CLEARGUARD 9 WATT UV COMPONENTS

DESIGN DIFFERENCES

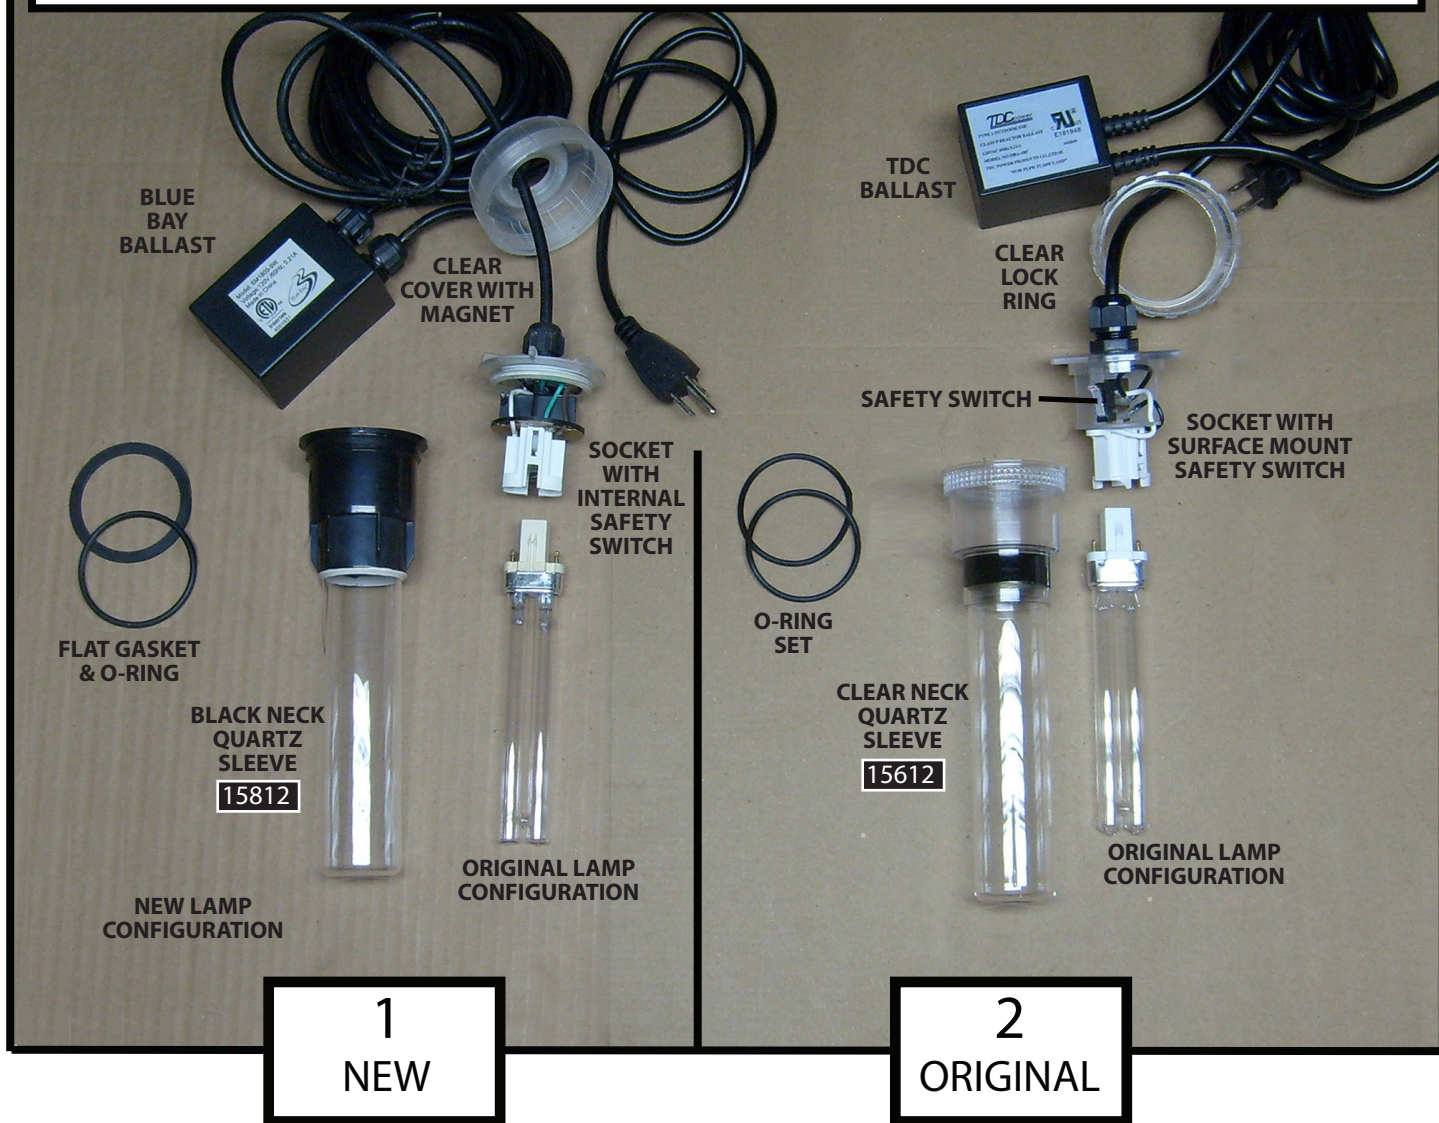
1) NEW DESIGN DESCRIPTION: New Blue Bay Ballast with three blade plug, Clear Cover with a ring magnet, Socket with built-in Internal Magnetic Safety Switch, Black Neck Quartz sleeve, Gasket / O-ring seal, Original 9 Watt lamp

2) ORIGINAL DESIGN DESCRIPTION: Original TDC Ballast with two blade plug, Clear Lock Ring, Surface mounted Safety Switch, Clear Neck Quartz Sleeve, Two O-ring seal, Original 9 Watt lamp.

1) NEW / ORIGINAL DESIGN COMPATIBILITY: New design uses the identical 9 watt lamp as the original design. The Black Neck Quartz sleeve from the new design can be used with the original design components, but always must be paired with the new flat gasket and Larger O-ring seal set.
